From: Larry Brandhorst <lbrandhorst@thearchitectsalliance.com>
Sent: Wednesday, November 18, 2020 3:08 PM
To: Jay Plett <jay@plett-arc.com>
Cc: Sean Mullin <SMullin@losgatosca.gov>; Ilona Merli <ilonamerli@gmail.com>; Karen Kurtz <KurtzK@comcast.net>
Subject: 101 Broadway House

November 18, 2020
Jay Plett, Architect
213 Bean Avenue
Los Gatos, CA 95030
Re: 101 Broadway House
Jay,

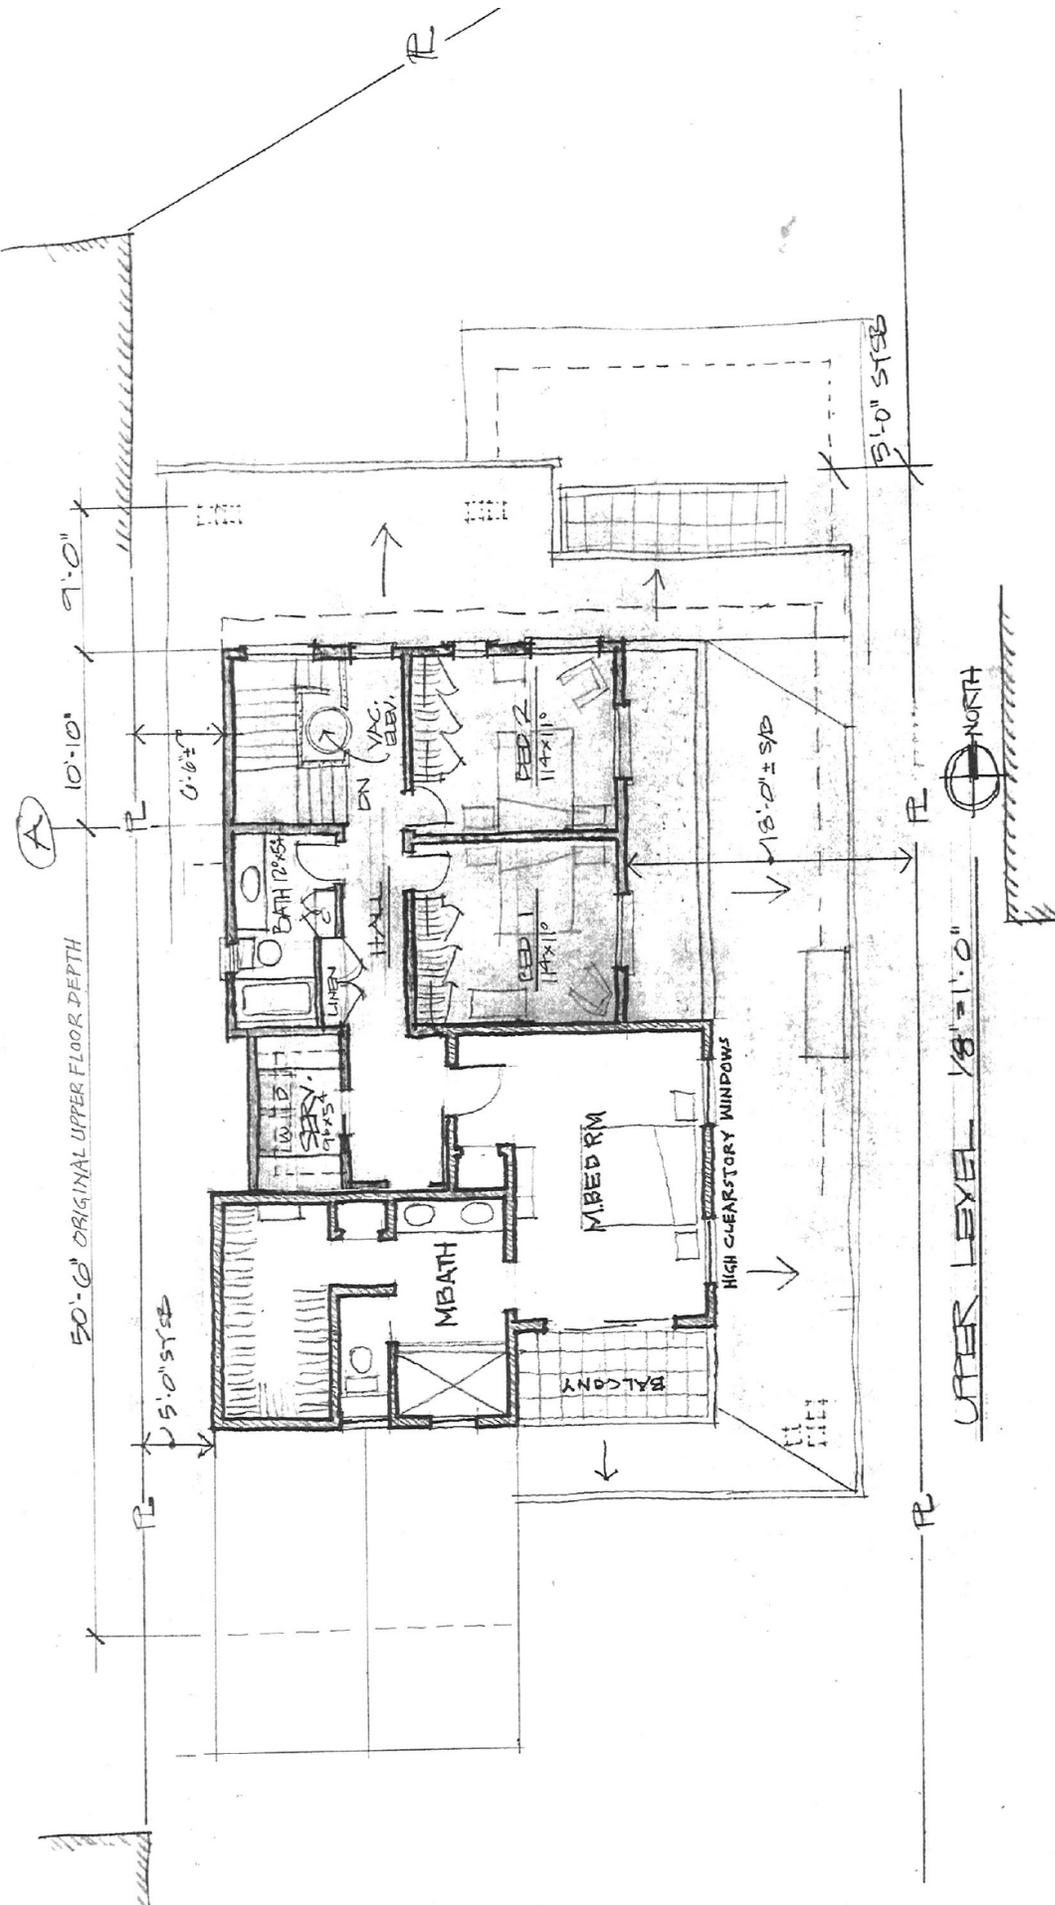
3) The revised plans lower the house about 1.5 feet which is good, but not enough to help with the privacy issues towards 93 Broadway Patio and upper level terrace.

4) Lowering the house and back patio area 1.5 feet helps with some minor privacy view overlooking the back patio and terrace towards 93 Broadway Historic House, however, it is still 6.5 feet above and overlooking the back patio at 93 Broadway Historic House.

Solution: Consider lowering the house an additional 1-2 feet. The driveway from Broadway to the garage has about a 4.5-6 feet rise in about 20 feet length which is a fairly steep drive; which would allow lowering the house. Plus, the house main floor level is 1.5 feet higher than the existing house main floor level, requiring about 1-2 feet of fill at the back part of the house, which would allow lowering the house.

Solution: Lowering the house more, as mentioned above, would continue to help with privacy and also installing a privacy screen fence along the East property line, to at least 4 feet above the 101 Broadway house back patio and would help with privacy screening towards 93 Broadway Historic House. Also, the only 4-foot high fence above the patio level would allow some privacy, but also allow some vision over the top of the fence to the horizon.
